# Access Compliance Report

## Public Rights-of-Way

### (Curb Ramps)

Intersection ID: 29961	Main Street: CANIPE_DR	Cross Street: HOLLOW_RIDGE_LN	Location: NE
ADA ID: B97A3461DB2F	Ramp Type: PerpDiag	Initial Pass/Fail: Fail	Overall Compliance: No
Severity Score: 21.25			
Codes/Mitigation Info/Possible Solution		Field Measurements/Component Compliance

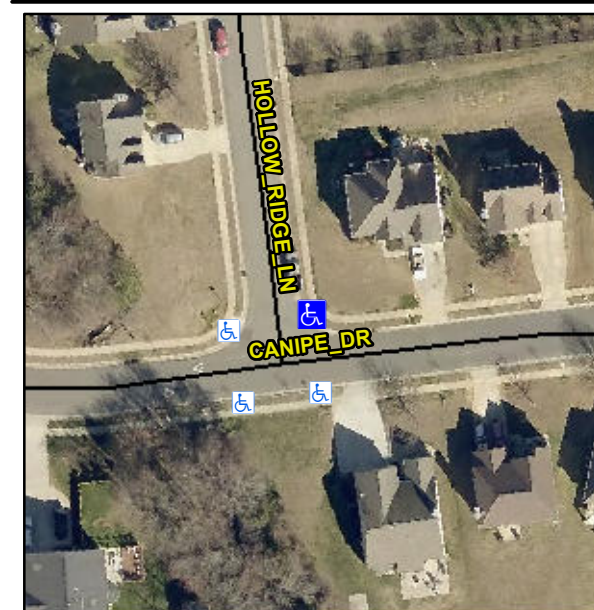
**Not Found, R304.5.1, R304.2.2**

Compliance	Description	Data	Compliance	Description	Data
N/A	Ramp Length (in)	43.5	No	Ramp Slope (%)	9.3
No	Ramp Width (in)	41.5	Yes	Ramp XSlope (%)	0.4
N/A	Flare Type LT	N/A	N/A	Flare Type RT	N/A
N/A	Flare Slope LT (%)	N/A	N/A	Flare Slope RT (%)	N/A
N/A	Flare Traversable LT?	N/A	N/A	Flare Traversable RT?	N/A
N/A	Landing Length (in)	N/A	N/A	DWS Provided?	N/A
N/A	Landing Width (in)	N/A	N/A	DWS Contrast?	N/A
N/A	Landing Slope (%)	N/A	N/A	DWS Length (in)	N/A
N/A	Landing X Slope (%)	N/A	N/A	DWS Full Width?	N/A
N/A	Landing Curb? (Y/N)	N/A	N/A	DWS Offset (in)	N/A
N/A	Shared Landing?	N/A			
N/A	Gutter Ponding?	N/A	N/A	Gutter Slope (%)	N/A
N/A	Gutter Lip Ht (in)	N/A	N/A	Gutter X Slope (%)	N/A
N/A	Painted X Walk1?	No	N/A	Painted X Walk2?	No
	X Walk 1 Direction	To W		X Walk 2 Direction	To S
N/A	X Walk 1 Width (in)	N/A	N/A	X Walk 2 Width (in)	N/A
	X Walk 1 Slope (%)	4.9		X Walk 2 Slope (%)	3.9
	X Walk 1 X Slope (%)	3.7		X Walk 2 X Slope (%)	2.4

**Remove & Replace Curb Ramp With Two New Directional Ramps or Equivalent.**
